**Subject: Addendum to the Final Status Survey Plan for Section 2 of the
Whittaker Corporation Waste and Slag Storage Area
EnergySolutions Document No. 82A9564, Revision 3**

Document Title: Final Status Survey Plan – Section 2 of the Whittaker Site Document No. 82A9564, Rev. 3
Addendum No.: 1 Originator Kevin E. Taylor
For Site/Utility: Whittaker Site, Greenville, PA

ADDENDUM 1**FINAL STATUS SURVEY PLAN (FSSP)****SECTION 2 OF THE WHITTAKER CORPORATION
WASTE AND SLAG STORAGE AREA
REYNOLDS INDUSTRIAL PARK
TRANSFER, PENNSYLVANIA****ENERGYSOLUTIONS DOCUMENT NO. 82A9564, REVISION 3**

Figure 2-1
Whittaker Section 2 Pit Area - Samples Collected on July 7, 2006

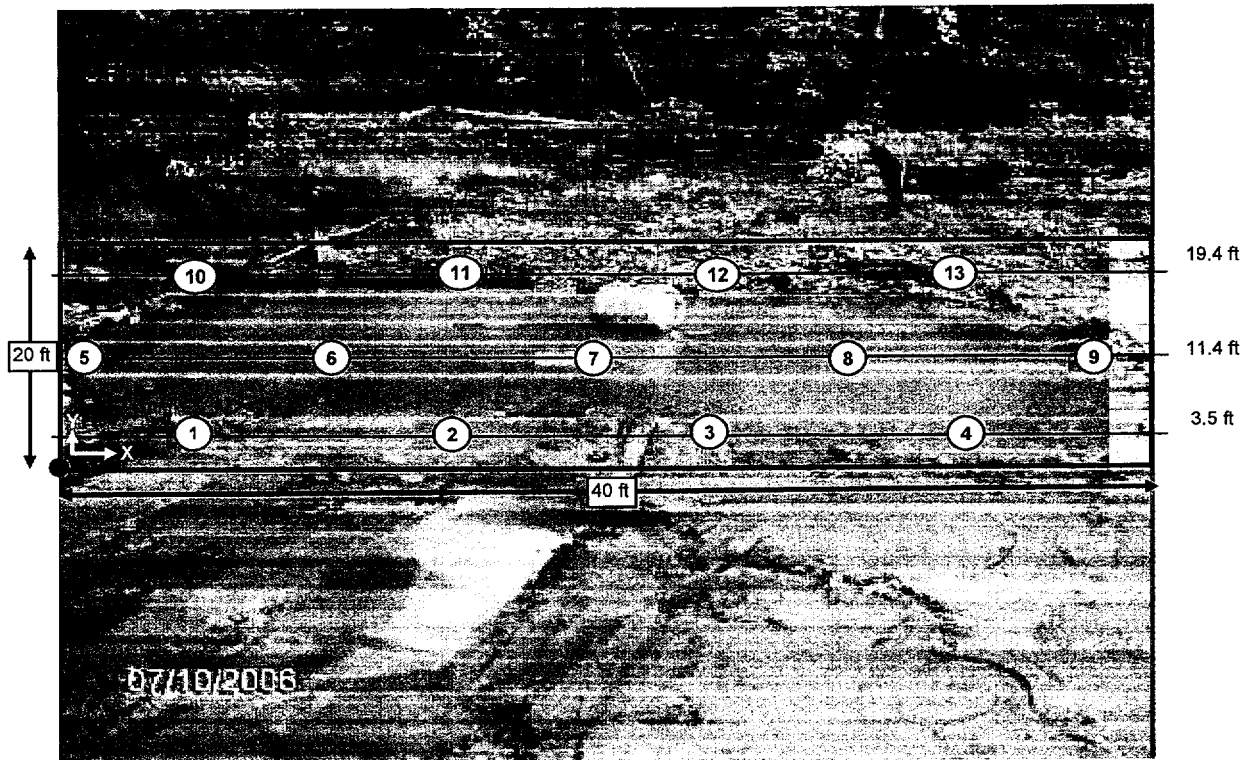
The pit area will be sampled using a random-start systematic triangular sampling pattern. As described in the FSS, a minimum of eleven samples will be collected from the area. The samples will be collected using clean sampling tools and dried.

Figure 2-1 provides the layout of the sample locations.

Sample No.	X	Y
1	5.5	3.5
2	14.7	3.5
3	23.8	3.5
4	33.0	3.5
5	0.9	11.4
6	10.1	11.4
7	19.3	11.4
8	28.4	11.4
9	37.6	11.4
10	5.5	19.4
11	14.7	19.4
12	23.8	19.4
13	33.0	19.4
